TC1766

32-Bit Single-Chip Microcontroller

TC1766 Documentation Addendum**Revision History: V2.0 2008-04**

This document describes corrections, changes, and improvements for the TC1766 User's Manual V2.0 2007-07, the System Units (Volume 1) and the Peripheral Units (Volume 2). These changes will be included in the next update of the User's Manual.

Figure 19-26 Receive Data Interrupt Control

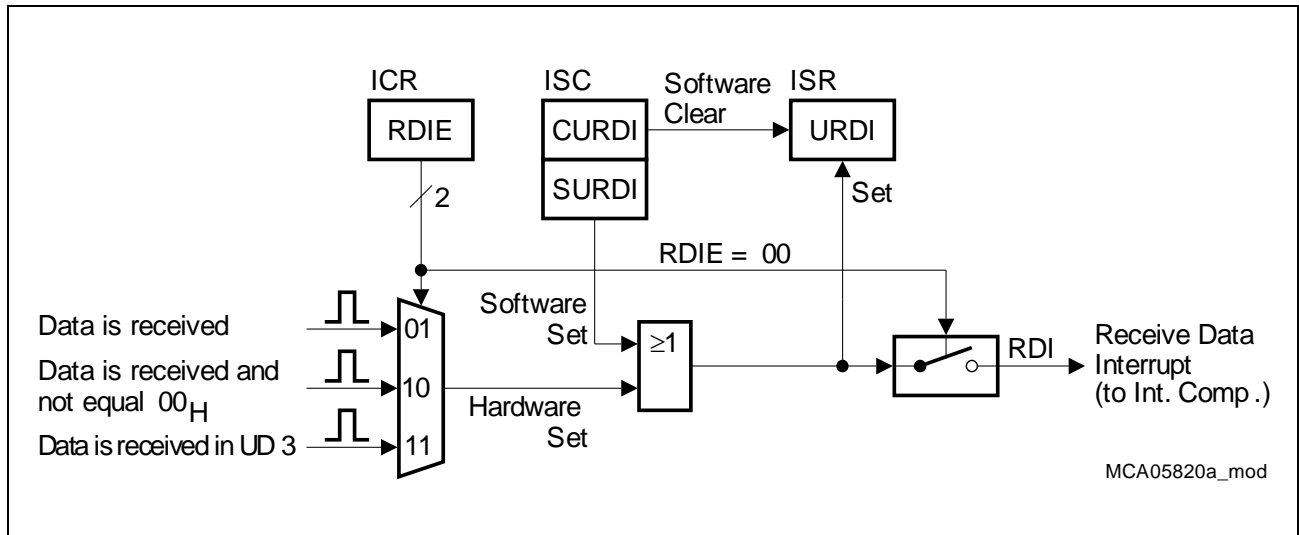
In the paragraph above Figure 19-26 "ISC.SRDI and ISC.CRDI" must be changed to "ISC.**SURDI** and ISC.**CURDI**".

Figure 19-26 must be updated with the following figure (output signal on the right side):
